**RE: 16940 Roberts Road**

I reviewed the drawings, and reviewed the site context. I have reviewed many homes nearby. My comments and recommendations are as follows:

## SITE PLAN

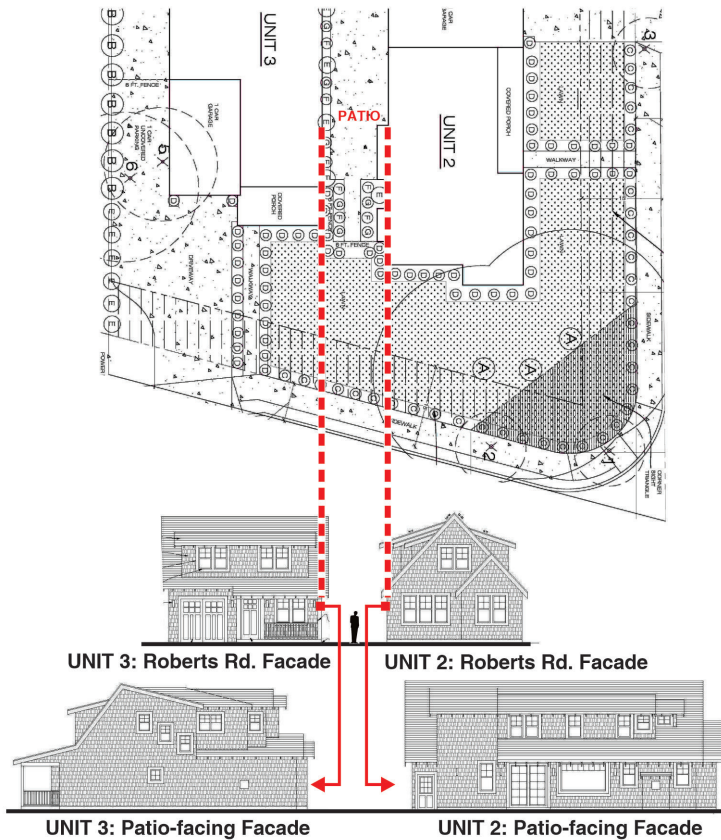
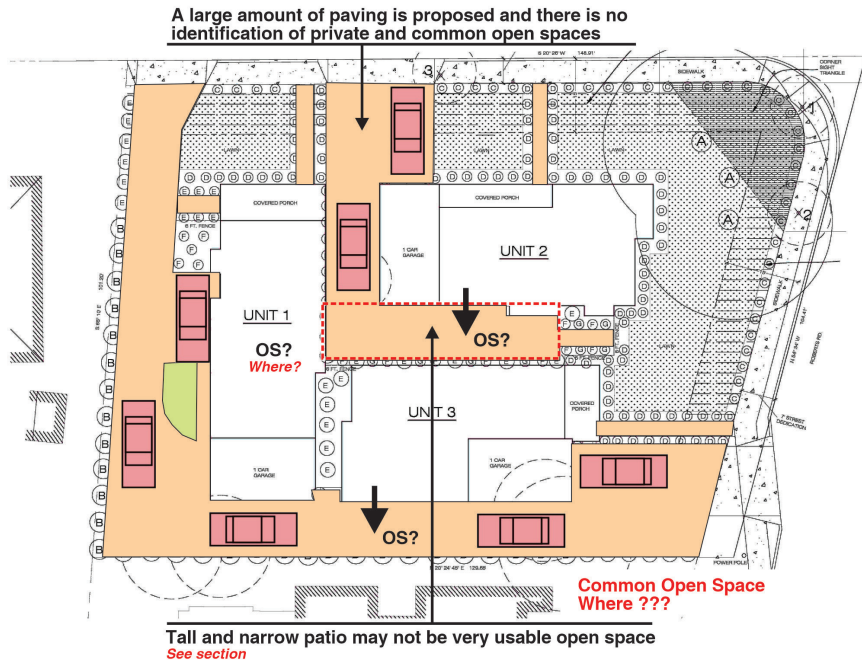
1. The proposed site plan has a large amount of paving relative to the overall site area.
2. The project data shows a calculation of private and common open space, but they are not designated on the site plan. Some spaces may not be very usable as open space. The one area that seems to be designated as open space, The Patio, is a tall and narrow space which would receive little sunlight.- see plan and section below.

1. Reduce the amount of site paving as much as possible.
2. Clearly delineate the proposed private and common open spaces.
3. Revise the Lot 2 Fisher Avenue elevation to break up the scale of the long elevation. One example is shown in the illustration below along with two good examples from the nearby Laurel Mews project.

*Lot 1: Left Side Elevation*

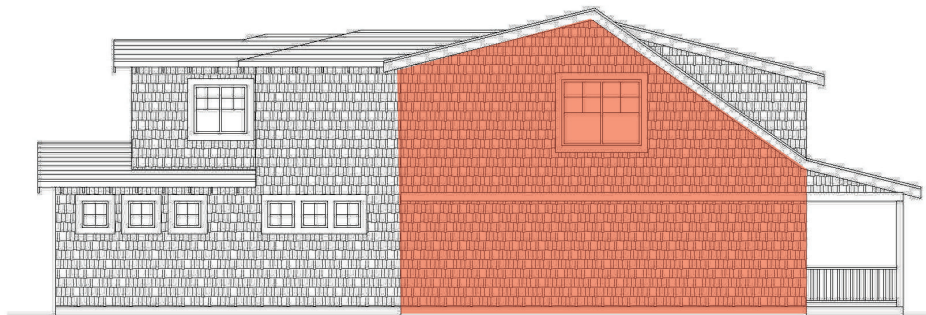
1. The two-story tall unbroken facade on the left side elevation would not be consistent with Residential Design Guideline 3.3.3.
2. The gas fireplace on the right side elevation without a chimney appropriate to the architectural style would not be consistent with Residential Design Guideline 3.10.4.

**Unbroken two-story wall is not consistent with Residential Design Guideline 3.3.3**

4. Add chimneys to the gas fireplaces to satisfy Residential Design Guideline 3.10.4.
5. Provide detail and/or articulation to two-story tall facades per Residential Design Guideline 3.3.3.

*Lot 1: Right Side Elevation*

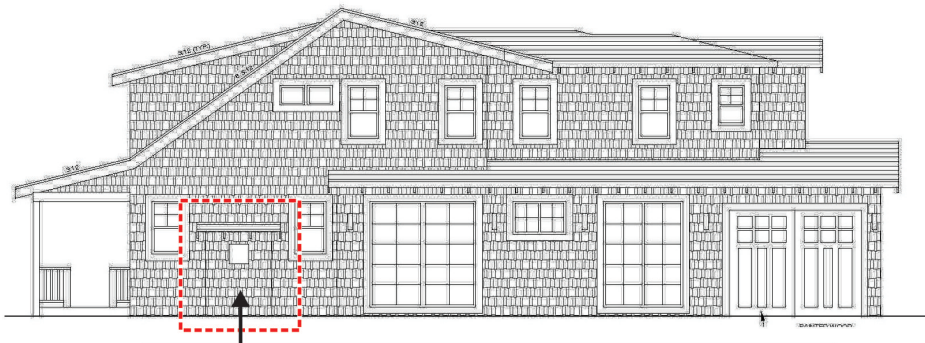
**Gas fireplace without a chimney suitable to the architectural style is not consistent with Residential Design Guideline 3.10.4**

*Lot 2: Front Elevation*

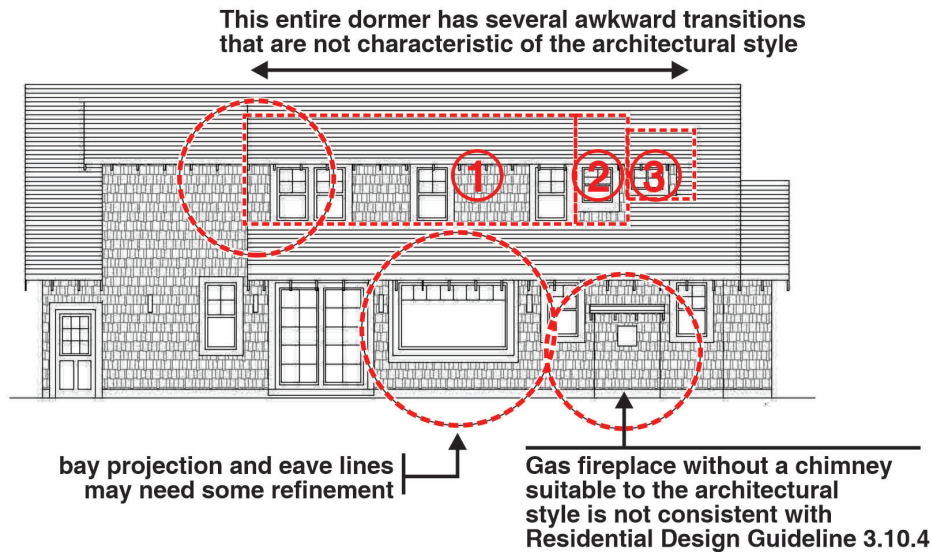
1. The front elevation, facing Fisher Avenue, is rather long, and does not work as well in its streetscape integration with the other street-facing facades here and at the Laurel Mews project a block to the east.

**Facade is very long and works against feeling of smaller street-facing facades**  
*See recommendations elevation below and review Laurel Mews photo examples*

*Lot 2: Rear Elevation*

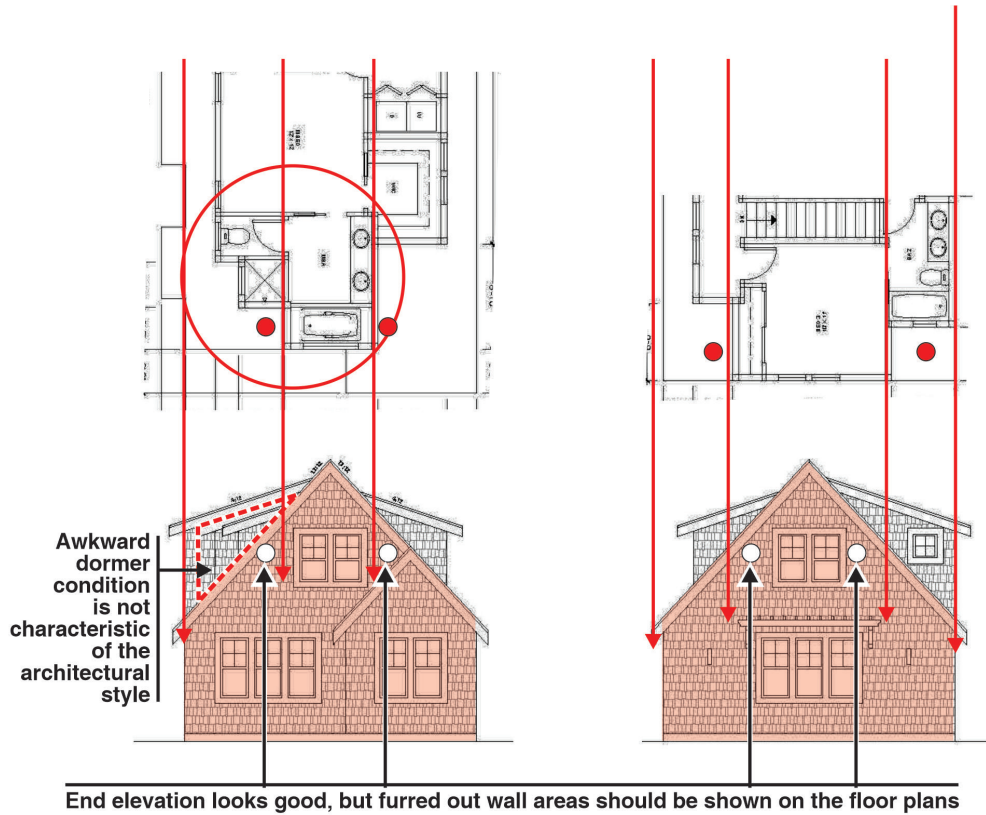
2. The shed roof dormer on the rear elevation has a number of awkward transitions that are not characteristic of the architectural style.

3. The end elevations are well done, but appear to rely on furred-out wall areas to achieve the simple, clean lines.

*Lot 3: Front Elevation*

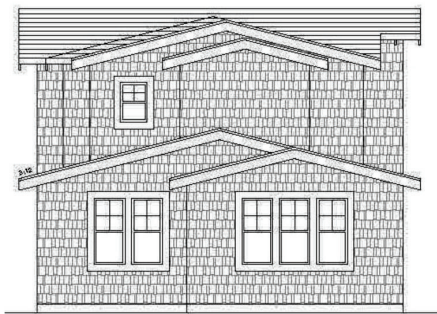
1. The two-story tall unbroken facade on the both side elevations would not be consistent with Residential Design Guideline 3.3.3

Unbroken two-story wall is not consistent with Residential Design Guideline 3.3.3

Lot 2: Proposed Fisher Avenue Elevation

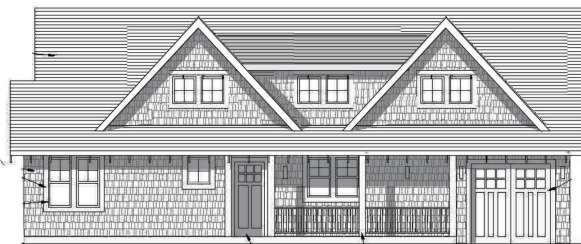
Lot 2: One Alternative Elevation Approach  
*See Laurel Mews examples for other approaches*
